ENGINE - AIR - INCORPORATE A CHAMFER OF THE ACAC INLET/OUTLET DUCT LUG - CATEGORY CODE
8 - MOD.ENG-75-0033

V2500-ENG-75-0033

ACAC INLET/OUTLET DUCTS – LOCATION OF ALTERATION
Fig.1

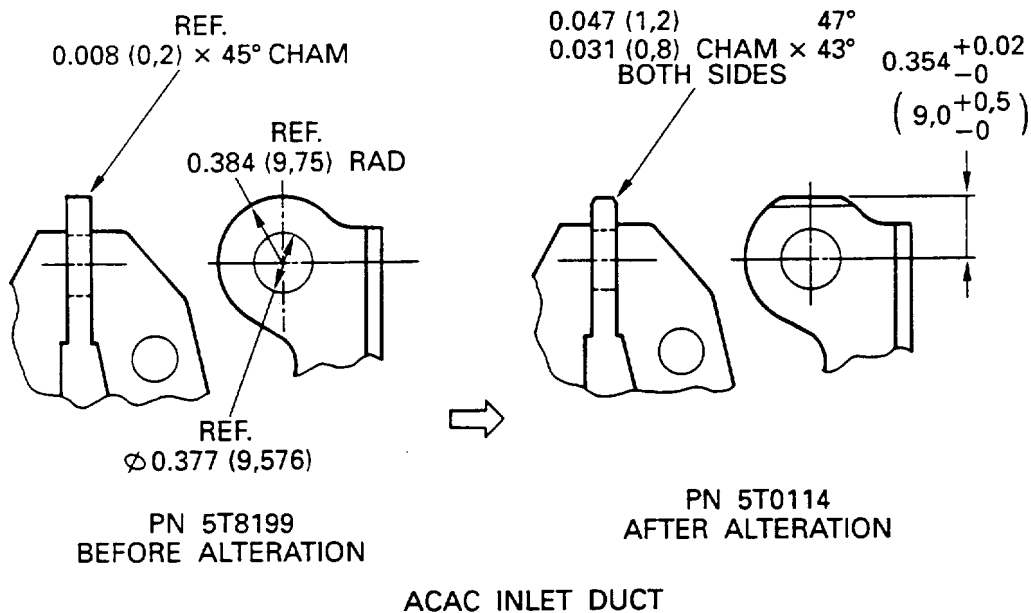
Larger chamfer is given to the shoulders of the lugs of ACAC Inlet and Outlet Ducts.

- (1) To rework the lug of ACAC Inlet and Outlet Ducts in accordance with Figures 1 and 2.

ACAC INLET/OUTLET DUCTS – BEFORE AND AFTER ALTERATION
Fig.2

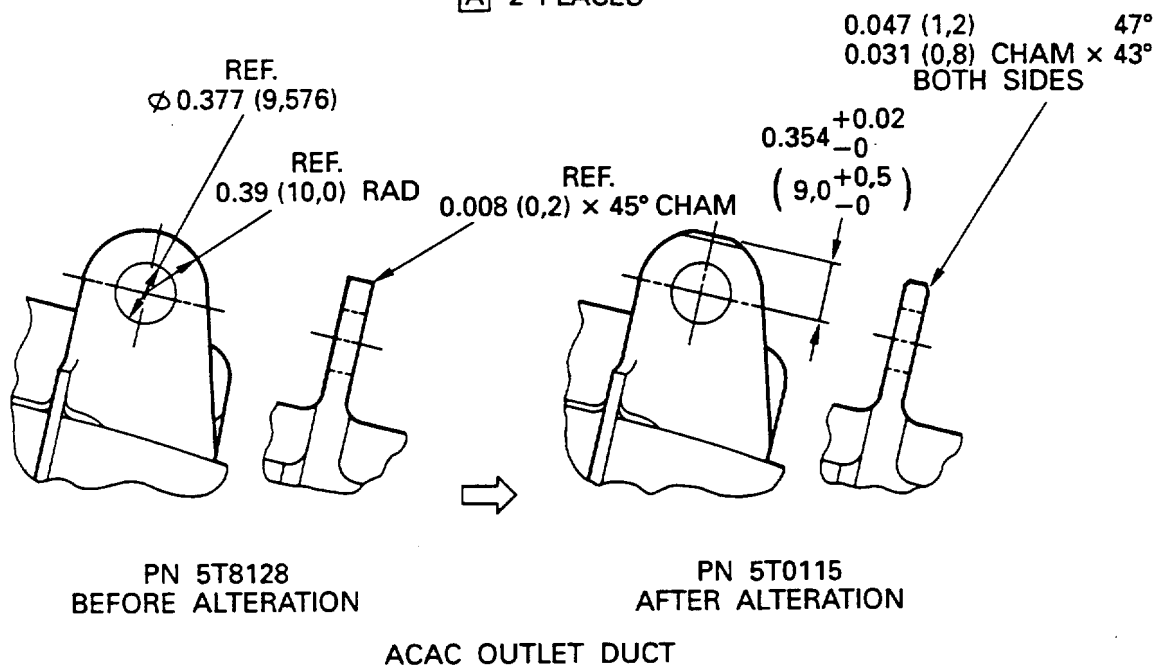
Length from center of hole to edge of lug is reduced to give clearance between the parts (See figure 2).
